ZHL-4240W+ PCN Report

AN-60-074

As a result of the introduction of a RoHS compliant version (+), non heatsink version, and assembly option at an alternate qualified Mini-Circuits facility, the replacement part has been judged by the Mini-Circuits Engineering team as a suitable replacement for the existing ZHL-4240W<sub>0</sub>.

**CASE STYLE**

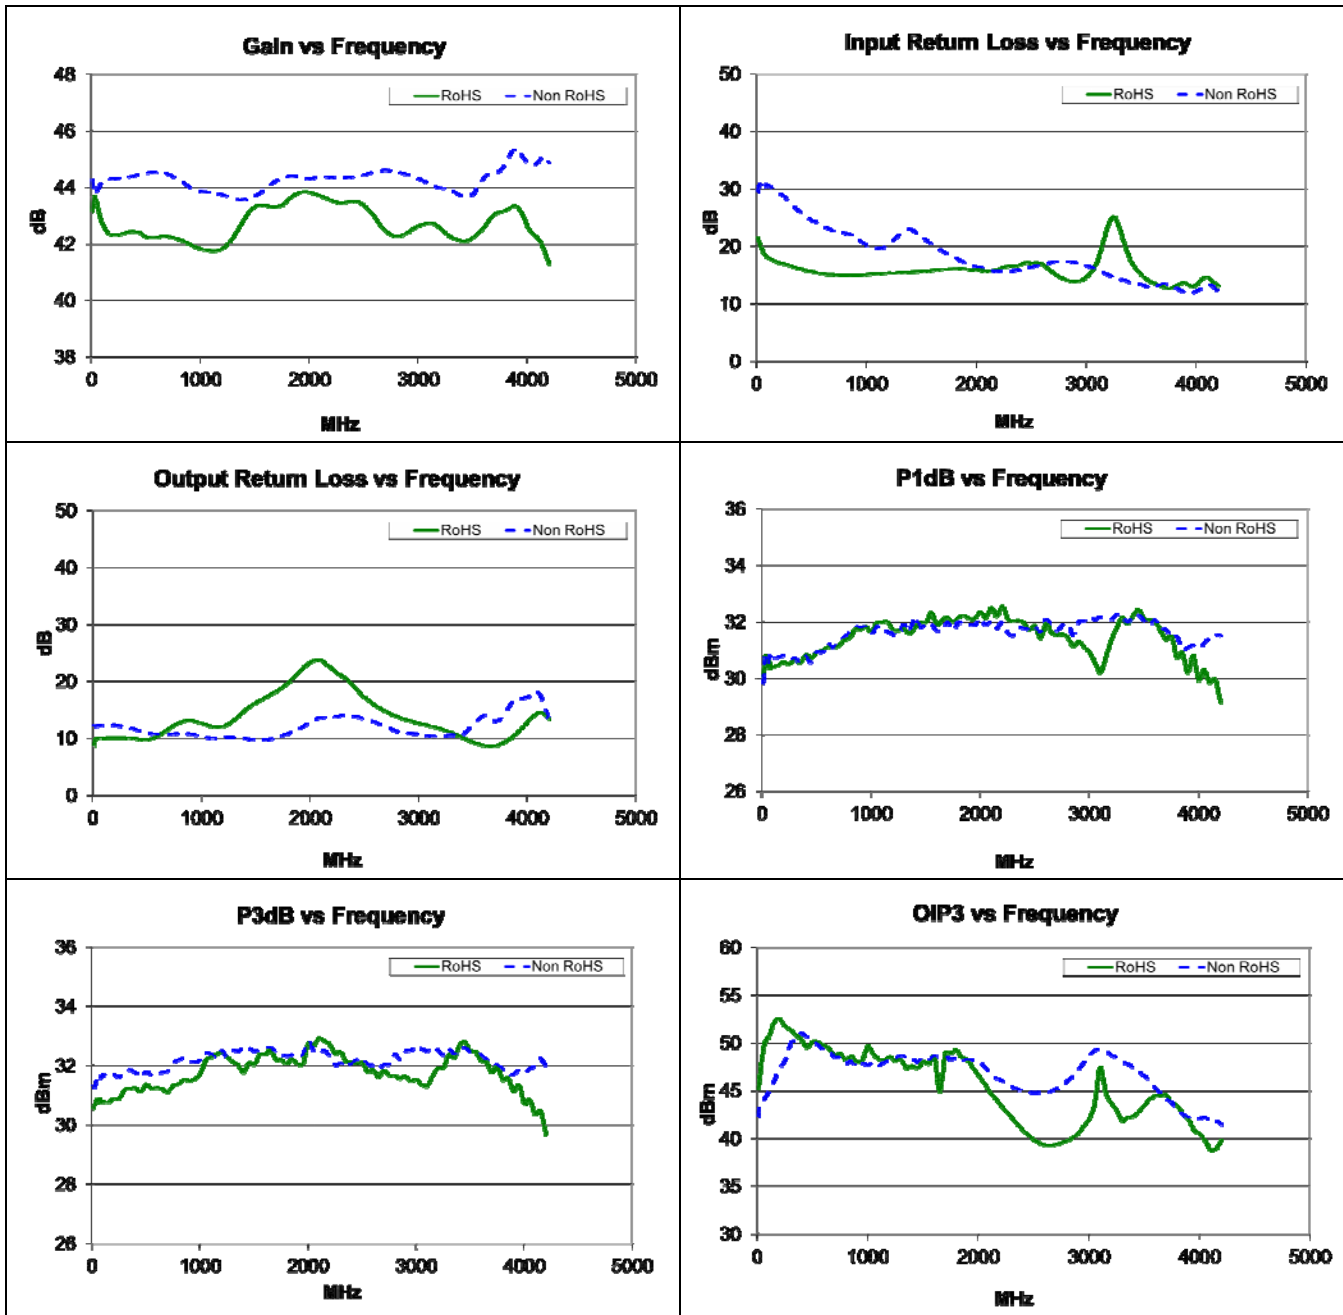
- 1) FIT and FORM are compatible with minor change: Create non heatsink version
- 2) Functional changes as follows:
